# Access Compliance Report

## Public Rights-of-Way

### (Curb Ramps)

Intersection ID: 10018967	Main Street: BRAWER_FARM_DR	Cross Street: N/A	Location: NE
ADA ID: 3012B4F27B89	Ramp Type: Perp	Initial Pass/Fail: Fail	Overall Compliance: No
Codes/Mitigation Info/Possible Solution		Field Measurements/Component Compliance

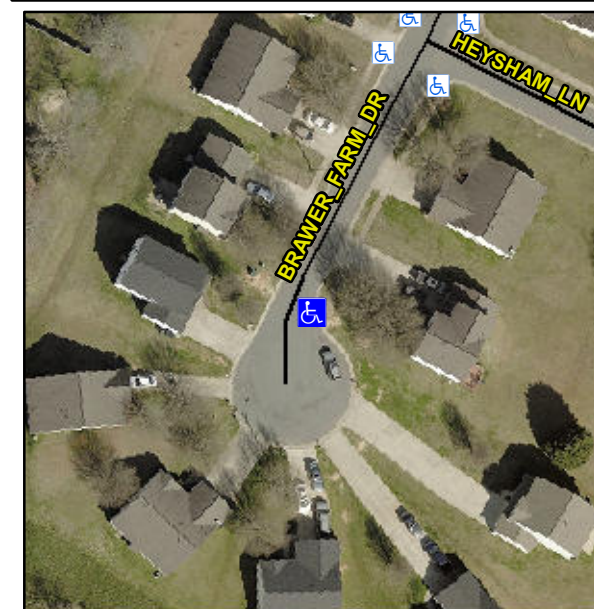
**Not Found, R304.5.1, R304.5.3**

Compliance	Description	Data	Compliance	Description	Data
N/A	Ramp Length (in)	46.5	Yes	Ramp Slope (%)	7.3
No	Ramp Width (in)	41.0	No	Ramp XSlope (%)	4.2
N/A	Flare Type LT	N/A	N/A	Flare Type RT	N/A
N/A	Flare Slope LT (%)	N/A	N/A	Flare Slope RT (%)	N/A
N/A	Flare Traversable LT?	N/A	N/A	Flare Traversable RT?	N/A
N/A	Landing Length (in)	N/A	N/A	DWS Provided?	N/A
N/A	Landing Width (in)	N/A	N/A	DWS Contrast?	N/A
N/A	Landing Slope (%)	N/A	N/A	DWS Length (in)	N/A
N/A	Landing X Slope (%)	N/A	N/A	DWS Full Width?	N/A
N/A	Landing Curb? (Y/N)	N/A	N/A	DWS Offset (in)	N/A
N/A	Shared Landing?	N/A			
N/A	Gutter Ponding?	N/A	N/A	Gutter Slope (%)	N/A
N/A	Gutter Lip Ht (in)	0.5	N/A	Gutter X Slope (%)	N/A
N/A	Painted X Walk1?	No	N/A	Painted X Walk2?	N/A
	X Walk 1 Direction	To SW		X Walk 2 Direction	N/A
N/A	X Walk 1 Width (in)	N/A	N/A	X Walk 2 Width (in)	N/A
	X Walk 1 Slope (%)	1.1		X Walk 2 Slope (%)	N/A
	X Walk 1 X Slope (%)	0.6		X Walk 2 X Slope (%)	N/A

N/A	Ramp inside XWalk1?	N/A	N/A	Ramp inside XWalk2?	N/A
	Road Slope (%)	N/A	N/A	Clear Space?	N/A
	Road X Slope (%)	N/A	N/A	Clear Space to XWalk (in)	N/A
N/A	Any Obstructions?	N/A	N/A	Storm Grate/Utility Hazard?	N/A
	Obstruction Type			Storm Grate/Utility Type	
		N/A			N/A
			Yes	Surface Condition? (G/P)	Good

**Remove & Replace Entire Ramp.**
